ENVIRONMENTAL REVIEW TEAM REPORT

AMITY VILLAGE SUBDIVISION
BETHANY, CONNECTICUT

JULY 1980

FIGURE 2.
SIMPLIFIED SITE PLAN

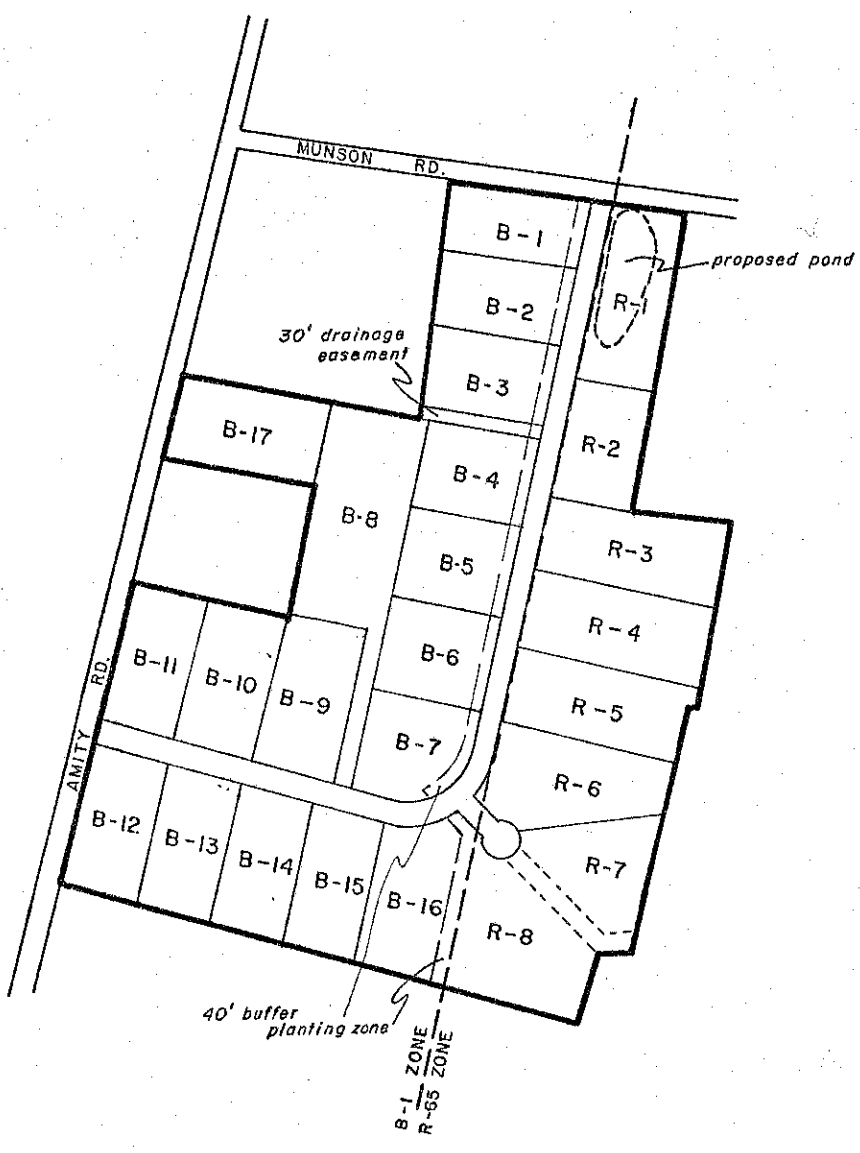
From a hydrologic standpoint, the layout of the proposed road and several of the lots represents the least acceptable usage of the land. The road's north-south segment cuts through the center of the stream-wetland system, providing maximum disruption of surface waters and enhancing both the potential for degradation of water quality and the possibility of flood-related problems both on and off the site. Moreover, wet soil conditions would hamper the placement of building foundations and, particularly, septic systems in those parts of lots B-1 through B-7 that would front on the road (presumably the most desirable parts of the lots for construction). Construction and maintenance of the road itself would be more difficult, as well. If environmental hazards are to be minimized on this site, the layout of the subdivision should be redesigned.

The layout of the proposed subdivision could be improved to better accommodate business use adjacent to residential use. It is not desirable to have business lots fronting on the opposite side of the road from residential lots. This presents a hazard with delivery trucks etc. utilizing the road and children in the immediate area, and also detracts from neighborhood identity, character and values. It would be far better to establish two separate road networks for this parcel: one serving the business lots and one serving the residential lots. Alternately, the two land uses could be separated on the same road system (i.e. residential use clustered at one end, business use at the other end).

FIGURE 3.
SHALLOW TO BEDROCK AREAS

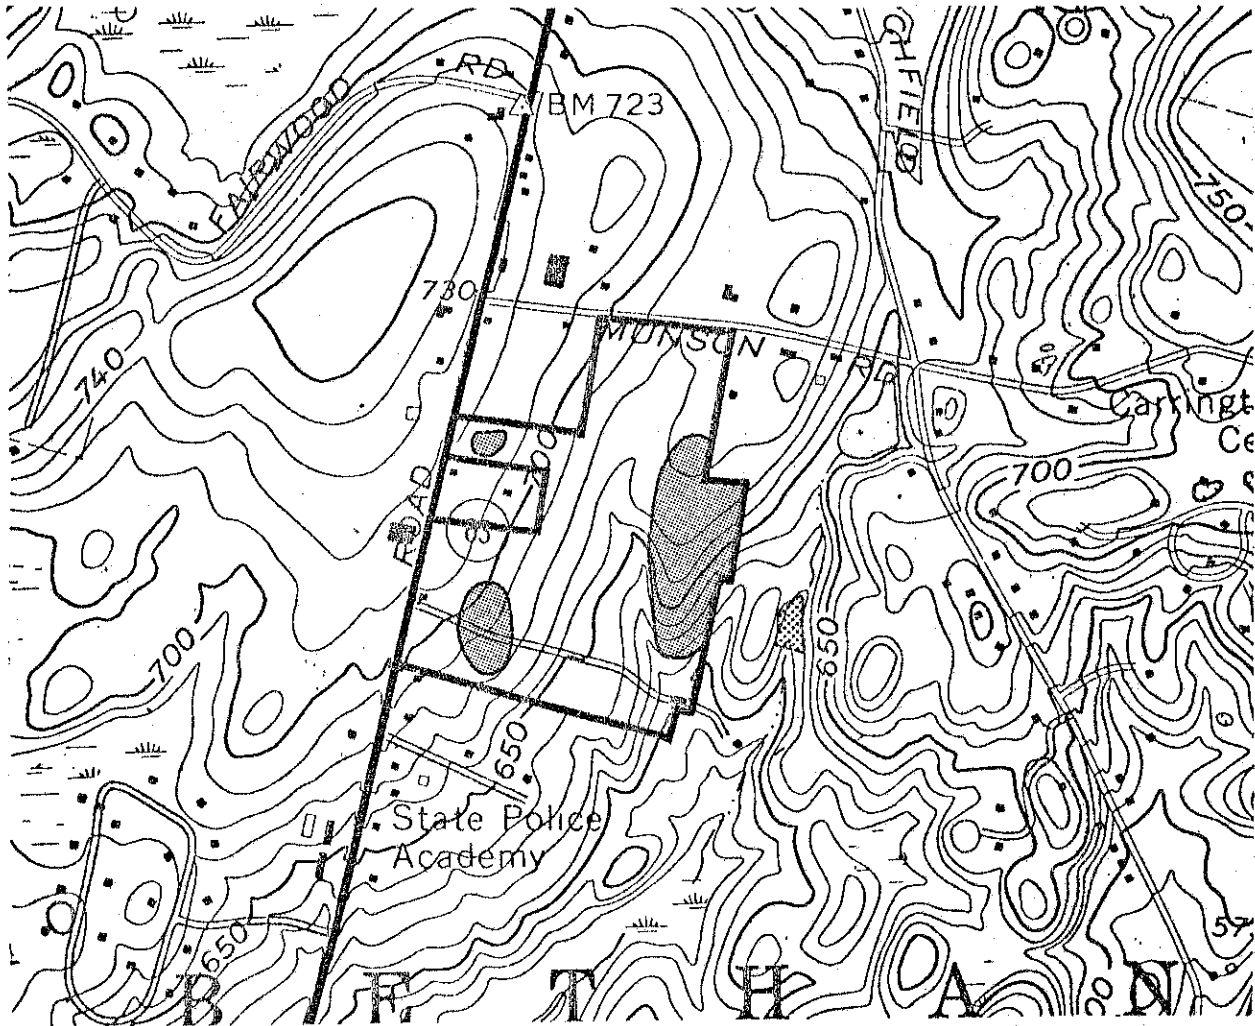
Test pit data submitted by William E. Gilbert Associates, Consulting Engineers, shows the variability of the till within the site. Textures described in the data range from "clay" or "hardpan" to "fine medium sand with cobbles". Bedrock (ledge) was found within 4 feet of the surface in lots B-10, R-2, R-3, and R-4, and was found at depths between 4 and 7 feet in lots B-4, B-14, B-17, R-5, and R-6. Engineered septic system designs must usually be considered when bedrock is found less than 7 feet from the surface. Figure 3 shows the approximate extent of such shallow-to-bedrock areas on the site.

4) The project engineer's soil report indicated shallow to ledge rock depth on lots R4, R3, R2 and B10. It is a normal recommendation of the State Department of Health Services that no permit for sewage disposal be granted in areas where there is less than four feet of existing soil over ledge rock, even if fill is proposed. On this basis, the above mentioned lots are considered unsuitable for installation of a subsurface sewage disposal systems in their present condition. The owner/developer may make suitable site improvements as planned by a professional engineer and ask for reconsideration by the State Department of Health Services.

FIGURE 4.
CRITICAL SOIL AREAS*

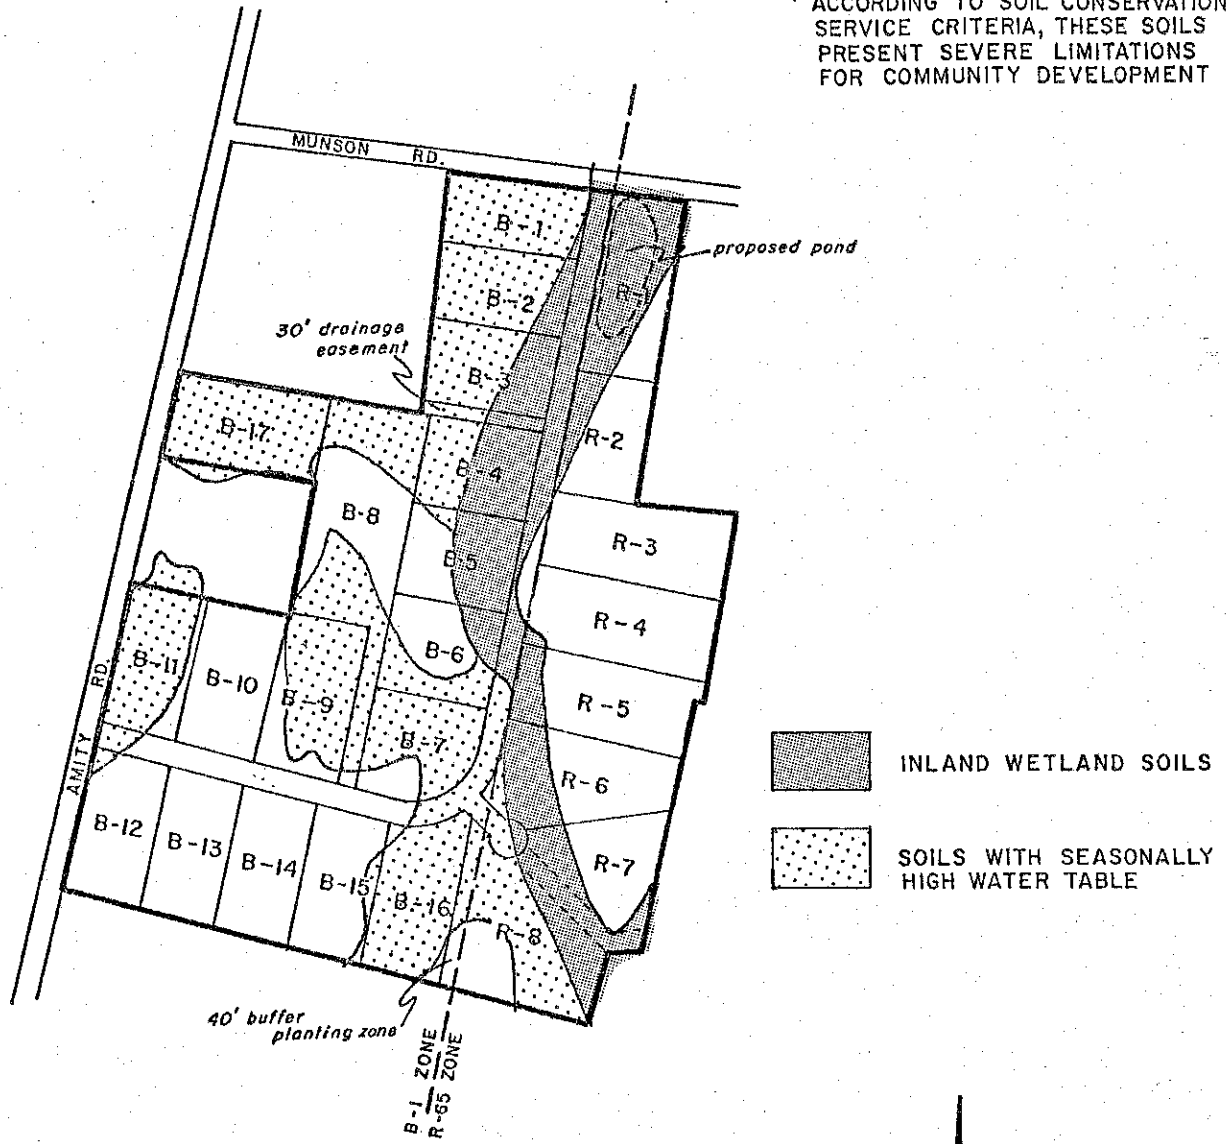
Finally, it should be noted that the inland wetland boundaries on this site were not flagged in the field. These should be flagged by a professional and competent soil scientist. The wetland boundaries should then be surveyed in the field and then properly superimposed on the subdivision plan. Also, the way the road is proposed, mainly through the middle of the inland wetlands, there is a very good possibility that the total wetland will be destroyed. Consideration should be given to re-designing the layout of the subdivision to avoid wetland soils.

The wetland associated with this stream also limits the usable land for septic systems from a practical standpoint. This concern is particularly significant with regards to lots R1, B3, B4, B5, R6, and R7 (see Figure 4).

FIGURE 5.
DRAINAGE AREA MAP (Drainage
area and discharge point used in hydrologic
analysis)

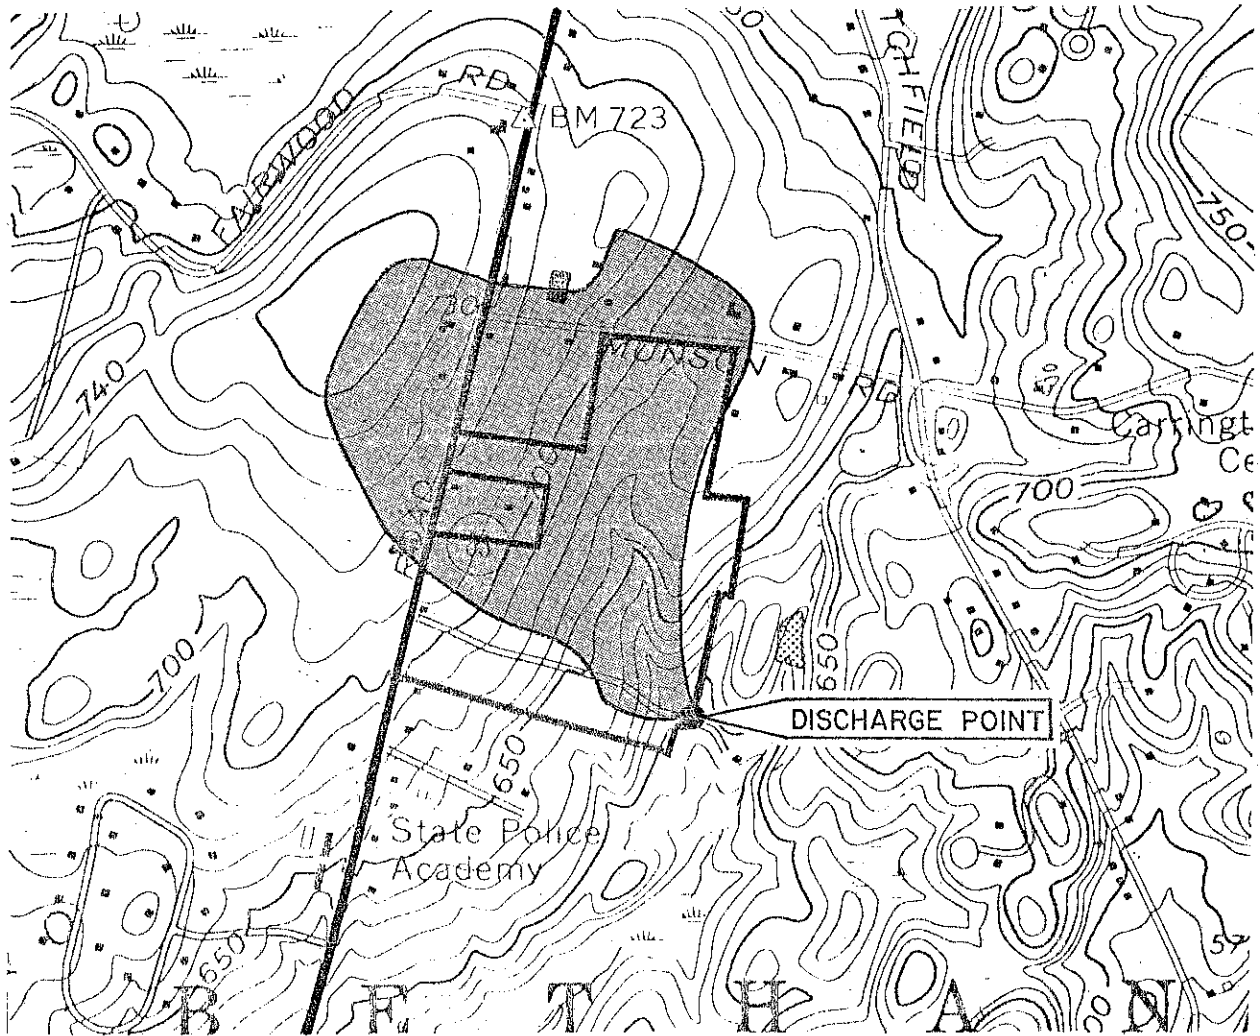
Construction of the subdivision as planned would lead to increases in runoff from the site and to increased peak flows in the local stream. The extent of the increases would depend upon the nature of the use of the various lots. In general, the most important factor would be the amount of new impervious surfaces that will be placed on the lots. Businesses tend to create impervious

As the figures given above suggest, peak flow increases in the stream may be expected to be substantial following development. Since a flooding problem is already known to exist in the area of the study point (local residents informed the Team that the house at the end of the driveway is effectively isolated by floodwaters during heavy rains), it seems essential that some means of runoff retention be provided on the site to prevent increased flood damage downstream. The pond proposed for the northern end of the site would not be in a hydrologic position to noticeably mitigate the increased runoff flows from the site; a retention pond near the existing driveway would offer maximum protection.

FIGURE 6.
VEGETATION TYPE MAP

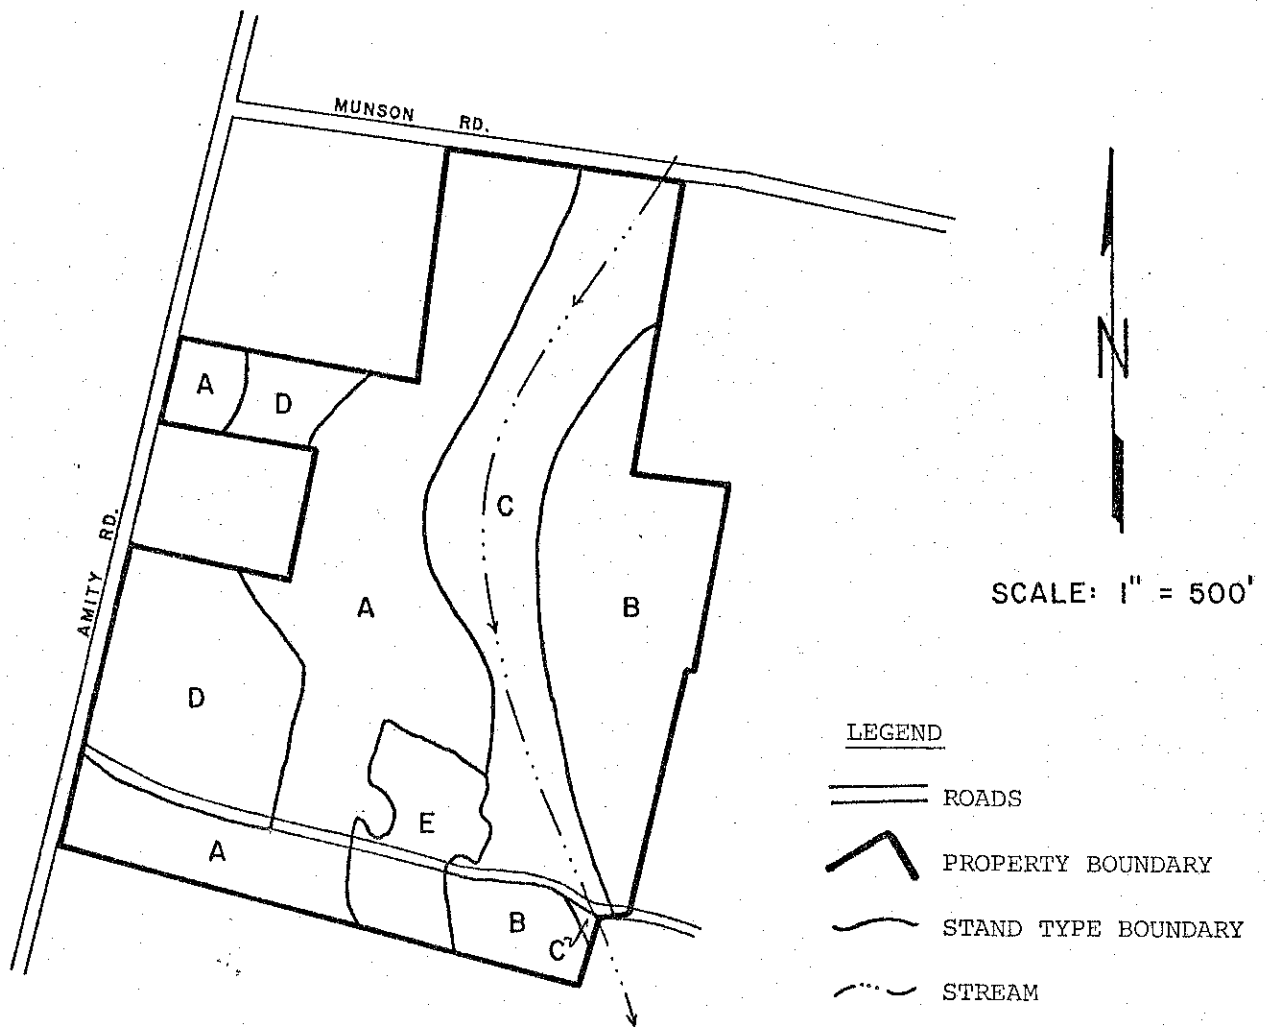
Complete clearing of the vegetation in the business zoned area and road construction in its presently proposed position will have significant negative effect on the vegetation in the area and may lower water quality.

Retention of at least some of the large healthy trees on this tract, especially in vegetation types A and E, will help to preserve the aesthetic quality of the area.

The high water table in the hardwood swamp limits vegetative quality and composition. Wind-throw of the shallow rooted trees in this area is a potential hazard. Removal of the red pine mortality in the mixed hardwood stand (B), prior to any construction, will reduce the potential hazard of these trees damaging property.
